TECHNICAL SERVICE BULLETIN

Soft Top Roof – Rear Window Scratching Paint On Rear Quarter Panel

23-2117

Ford 2021-2022 Bronco

Figure 1 – Left/rear shown, right/rear similar.

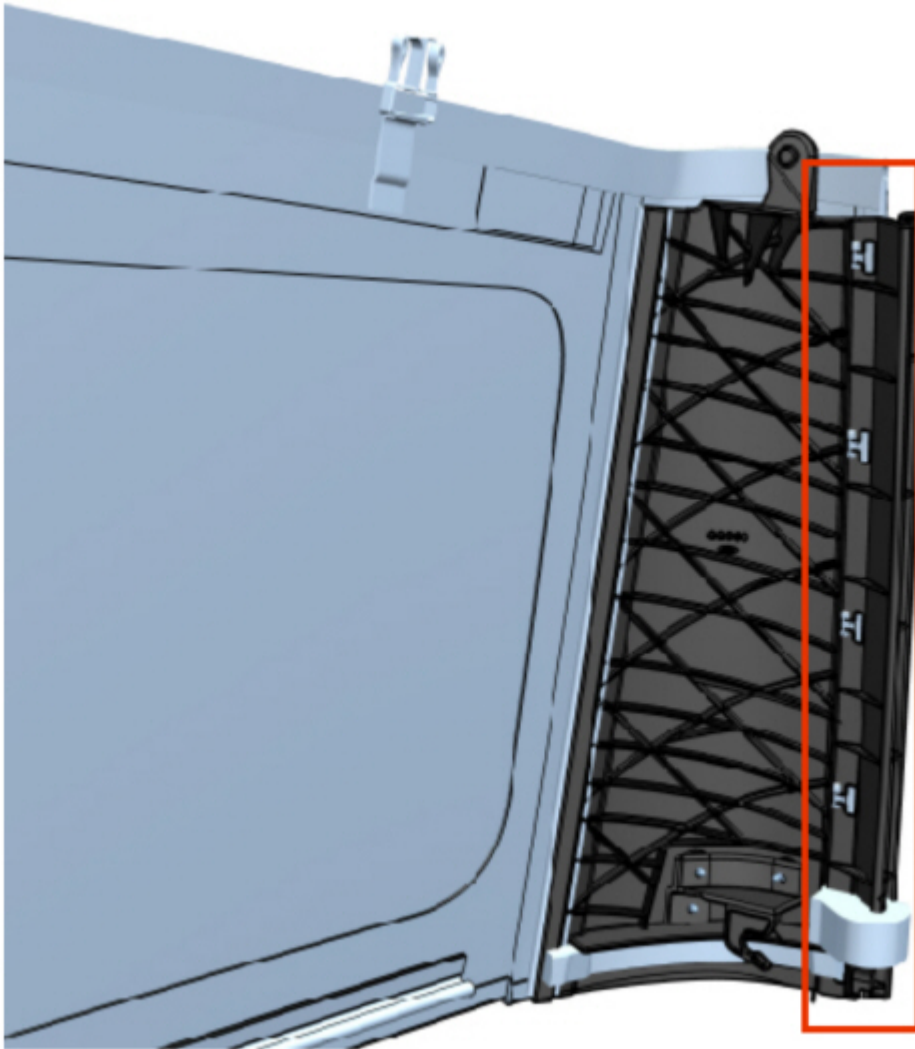
Issue: Some 2021-2022 Bronco vehicles may exhibit paint damage on the rear quarter panel due to contact with the rear window assembly (D-pillar). This may be due to an oversized washer being used during production. To correct the condition, repair the paint damage to the rear quarter panel and replace the rear window assembly.

1. Remove the rear window and both rear quarter window assemblies. Refer to the Workshop Manual (WSM), Section 501-18A > Removal and Installation > Soft Top Assembly.
2. Does the vehicle have paint damage on the rear quarter panel like the damage shown in Figure 1?

- (1). Yes – proceed to Step 3.
- (2). No – this article does not apply.

Figure 2 – Left/rear shown, right/rear similar.

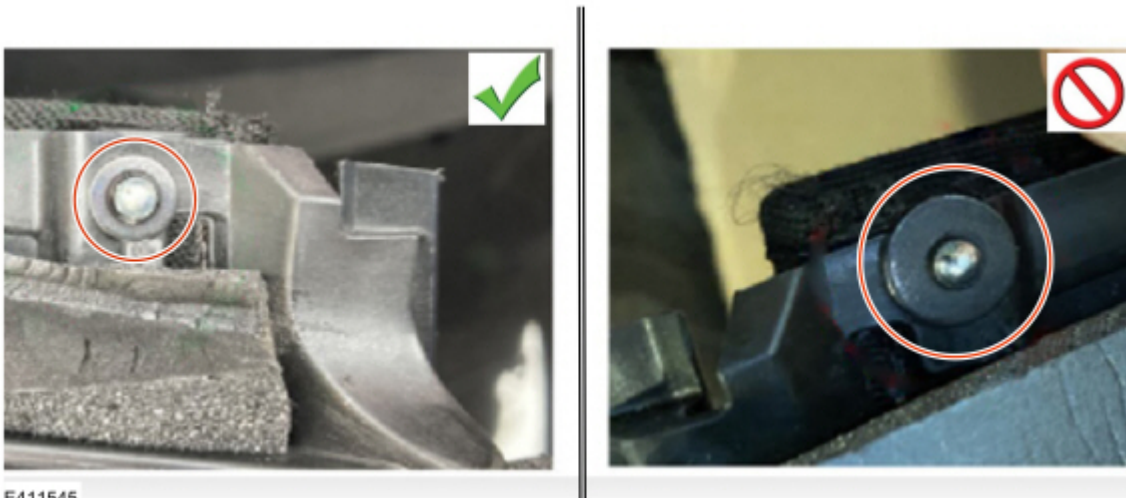
3. Are metal rivets and washers installed on the rear window D-pillars? (Figure 2)

NOTE: Metal Rivets with metal washer backings were added to Bronco soft top rear window production in early 2022. When inspecting the rear window D-pillars, each D-pillar may have 0, 3 or 5 metal rivets with washer backings installed depending on when it was built. All versions are acceptable.

- (1). Yes – proceed to Step 4.
- (2). No – this article does not apply.
